City of Alexandria, Virginia

MEMORANDUM

SUBJECT: 111 SOUTH PAYNE STREET

Docket Item # 7
BAR CASE # 2013-0292

Figure #1: View from the public alley behind 111 South Payne Street

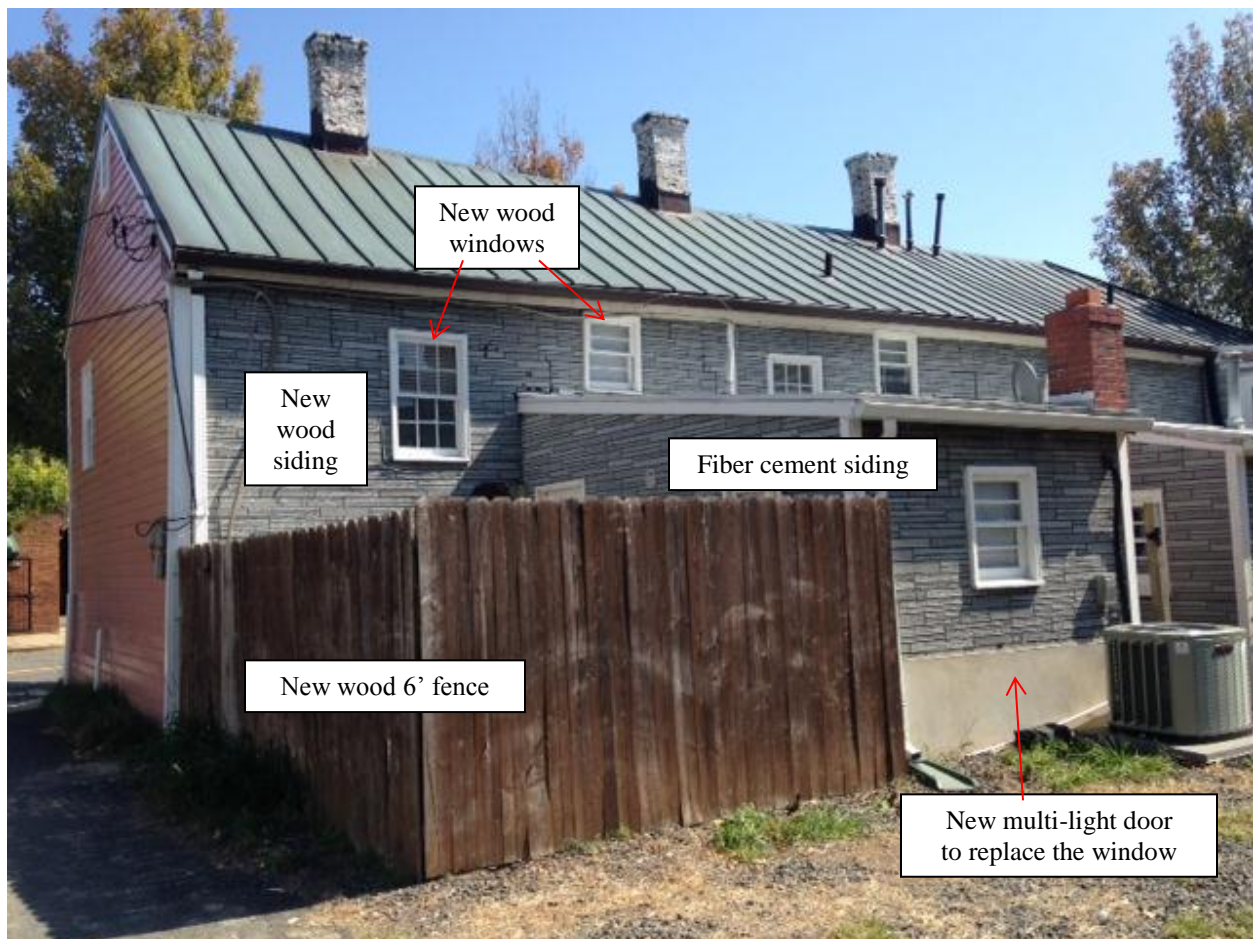
The applicant proposes to use wood windows and doors that comply with the Board's window policy on both the historic portion and the later addition. However, as with the fiber cement siding proposed on the mid-to-late 1960s rear addition, Staff could support the use of a greater palette of materials on this portion of the building, such as high quality simulated divided light fiberglass or aluminum clad windows and doors. As demonstrated by the photo below, the doors and windows on the ell will be minimally visible behind the 6' wood fence.

The applicant's materials show both a 6-over-6 and 4-over-4 window configuration; Staff recommends 6-over-6 windows on the main historic block, as this is the more appropriate for the mid-to-late 19th century portion of the building. The applicant has greater design flexibility on the addition and Staff supports 4-over-4 windows facing the enclosed patio. Staff can also support the multi-light doors proposed by the applicant but not the Craftsman style door because this early 20th century style it is not historically appropriate for any portion of this building.

1. That the applicant may use *new* wood lap siding on the rear elevation of the main, historic block, provided that it matches the profile and reveal of the existing historic wood siding;
2. That the applicant may use smooth, fiber cement lap siding only on the one-story rear addition;
3. That the windows on the original two-story portion of the building be constructed of wood in a six-over-six sash lite configuration and comply with the *Alexandria Window Replacement Performance Specifications*;
4. That the windows and doors on the one-story addition may be either aluminum clad wood or fiberglass, so long as these are in compliance with the *Alexandria Window Replacement Performance Specifications*;
5. That a 6 foot wood fence similar to the one shown by the applicant be installed; and,
6. That the two proposed signs are comply with the Board's sign policy.
